DANIEL DINKINS SUBDIVISION

APPLICATION NUMBER Holdover DATE December 21, 2006

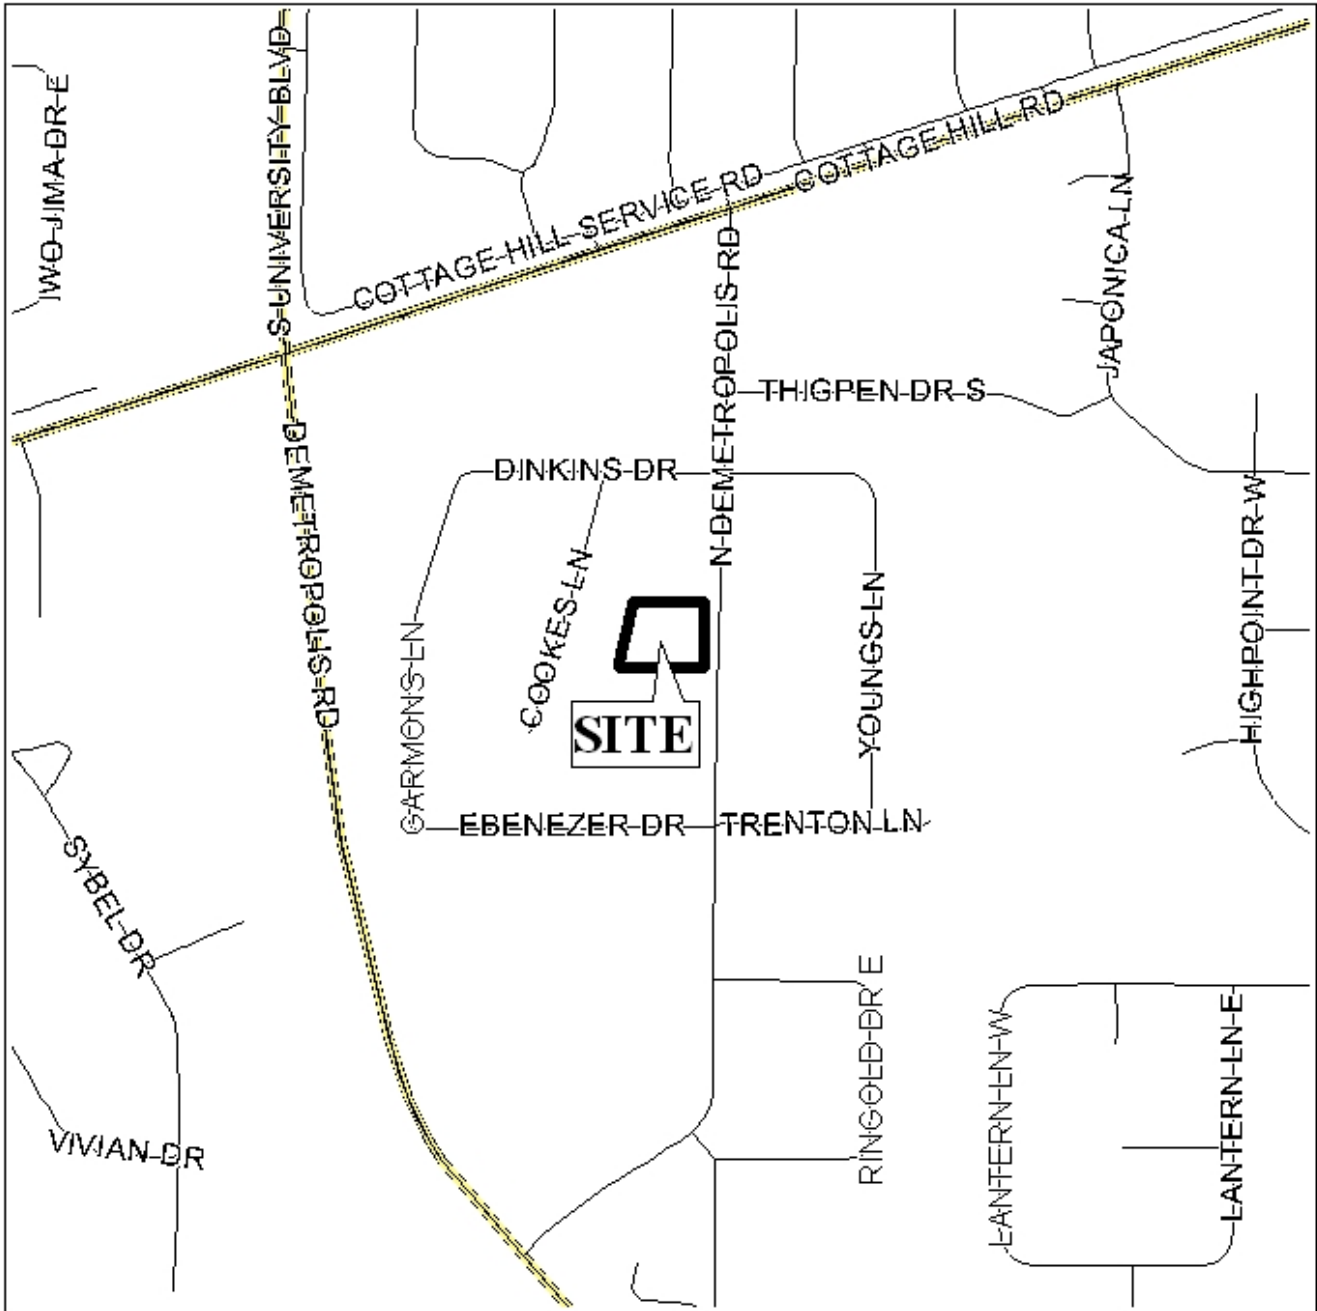
The plat illustrates the proposed 1.0 acre \pm , 2 lot subdivision which is located on the West side of Demetropolis Road, 245' \pm South of an unopened, unnamed public right-of-way, and is in Council District 4. The applicant states that the subdivision is served by both public water and sanitary sewer.

The purpose of this application is to subdivide a parcel into two legal lots of record. It appears that the parcel depicted on the plat may include property owned by the City of Mobile, instead of the easement depicted on the plat. The legal boundaries of the parcel in question should be verified and the plat revised as necessary.

The site fronts onto North Demetropolis Road, a minor street with adequate right-of-way. While North Demetropolis Road is a minor street, access management is a concern. Each proposed lot should be limited to one curb-cut each, with the size, design and location to be approved by Traffic Engineering and comply with AASHTO standards.

The 25-foot minimum building setback line, required in Section V.D.9., is not shown for the subdivision, but would be required on the final plat, if approved.

Based on the preceding, the plat is recommended for Holdover until the December 21st meeting to allow the applicant's representative to verify the boundaries and ownership of the parcel.

Based on the preceding, the plat is recommended for Denial for the following reasons: 1) no information has been provided regarding the acceptance of the survey by the applicant; and 2) no revised plat was received excluding the City-owned land on the southern portion of the site.
